# UNITED STATES PATENT AND TRADEMARK OFFICE

APPLICATION NO.	FILING DATE	FIRST NAMED INVENTOR	ATTORNEY DOCKET NO.	CONFIRMATION NO.
10/630,295	07/30/2003	Gilberto Goncalves Oliveira Filho	138330	9716

<b>Office Action Summary</b>	<b>Application No.</b>	<b>Applicant(s)</b>	
	10/630,295	OLIVEIRA FILHO, GILBERTO GONCALVES	
	<b>Examiner</b>	<b>Art Unit</b>	
	Korie H. Chan	3632

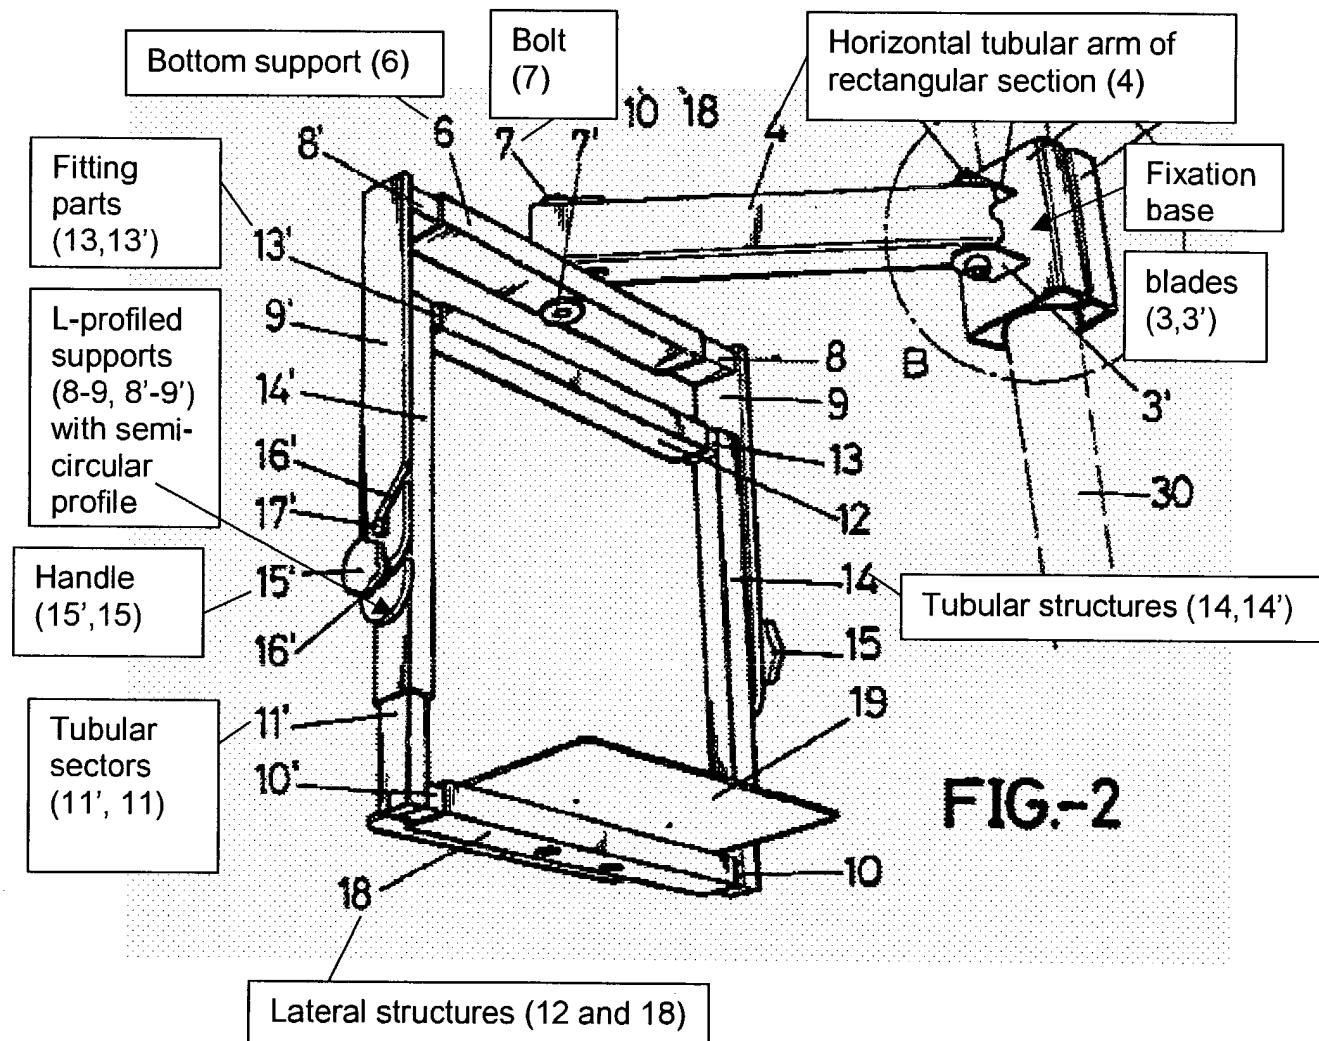
Claims 1, 2, 5, 6, and 8 are rejected under 35 U.S.C. 102(b) as being anticipated by Canton Gongora et al (US patent no. 5,797,568). Gongora disclosed all the claimed features of applicant's invention. (See examiner's illustration below)
